CITY OF SARATOGA SPRINGS
PLANNING BOARD

Joint Planning Board - Design Review Commission Meeting

- A. 15.041 77 Excelsior Mixed-Use Development
77 Excelsior Ave, Site plan review for mixed-use development with 90 multi-family residential units and 1,440 sq ft of commercial space in the Transect-5 Neighborhood Center (T-5) District.
Documents: 15.041 77EXCELSIORMIXEDUSE_APP_REDACTED.PDF, LA GROUP RESPONSE TO PLANNING COMMENTS 11.4.15.PDF, PLANS UPDATED 11-4-15.PDF, WATER SERVICE CONNECTION AGREEMENT.PDF
- B. 16.015 West Ave Mixed-Use
106-120 West Ave, Sketch site plan review for mixed-use development of 36 residential units and 4,100sf of commercial within the T-5 District.
Documents: 16.015 WESTAVEMIXEDUSESKETCH_CITYRESPONSEBRAINCCORR5-19-16_REDACTED.PDF, 16.015 WESTAVEMIXEDUSESKETCH_CORRBRAIN5-19-16_REDACTED.PDF, 16.015 WESTAVEMIXEDUSESKETCH_APP_REDACTED.PDF

1. Project Name: 77 Excelsior Mixed Use Development

Layout & Materials Plan

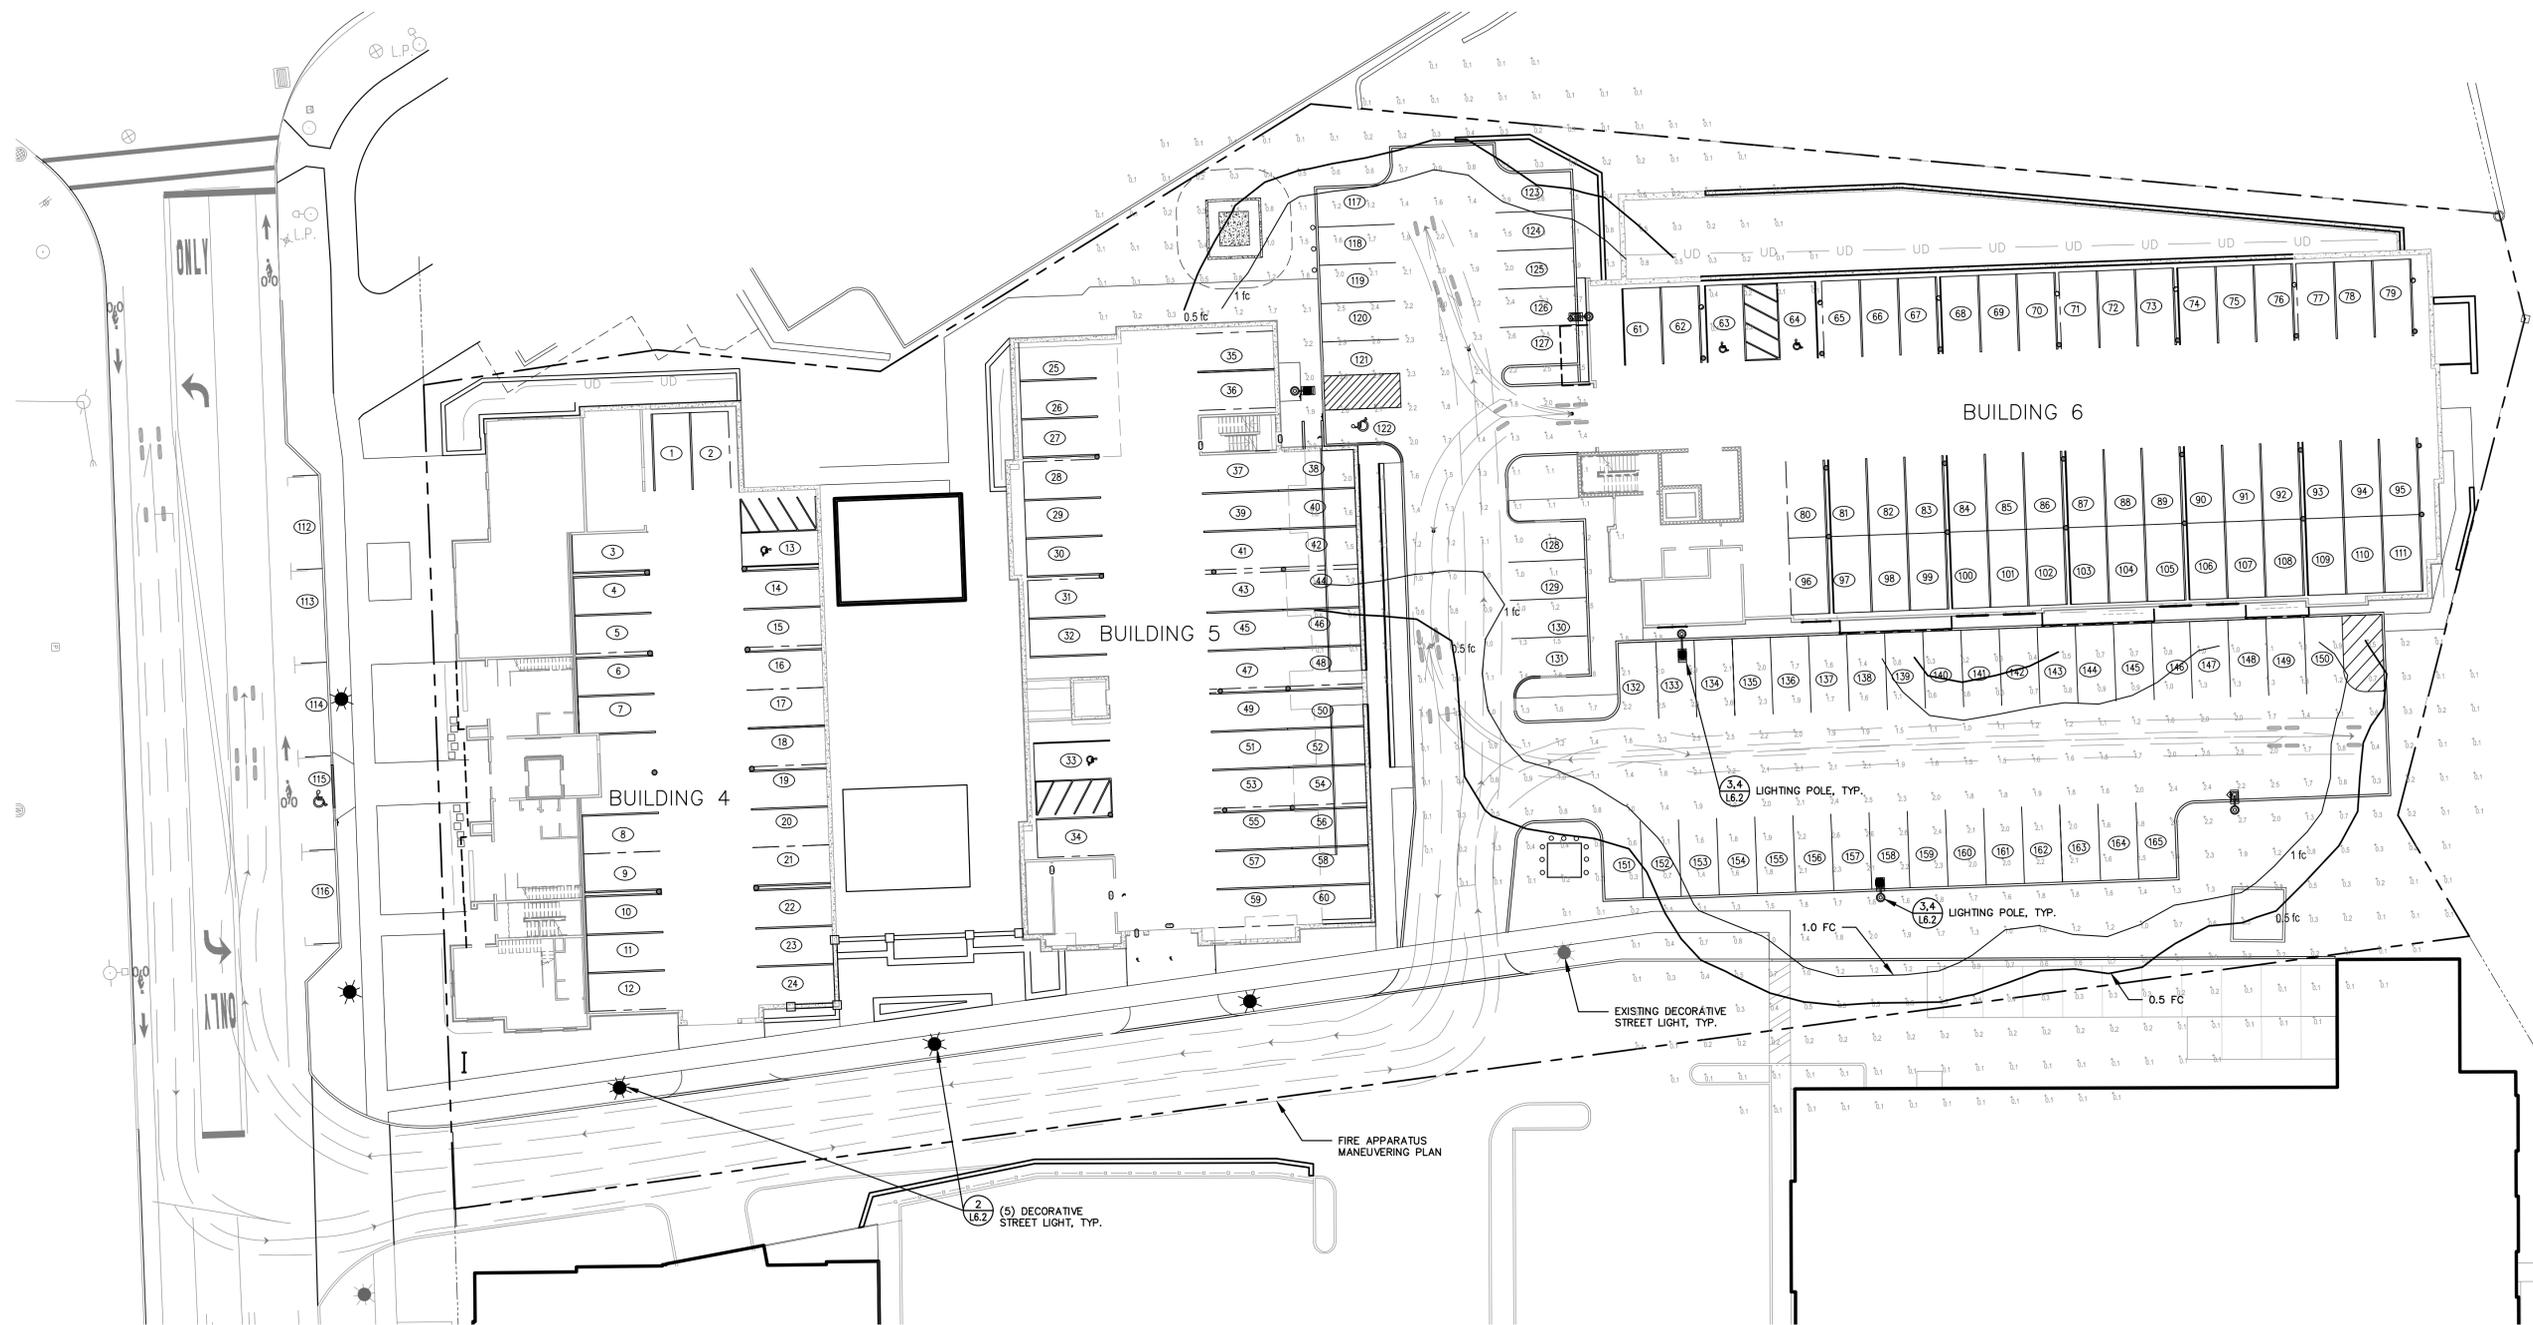
Comment: Walk in office portion of 3 live/work units – present at grade. Note should be added to plans that require ground level space to remain commercial.

Comment: Bike lanes need to be shown on plan.

Response: A note has been added to Layout & Materials Plan indicating ground level spaces shall remain commercial.

Response: Bike lanes are depicted on Sheet L-2.0, Layout & Materials Plan.
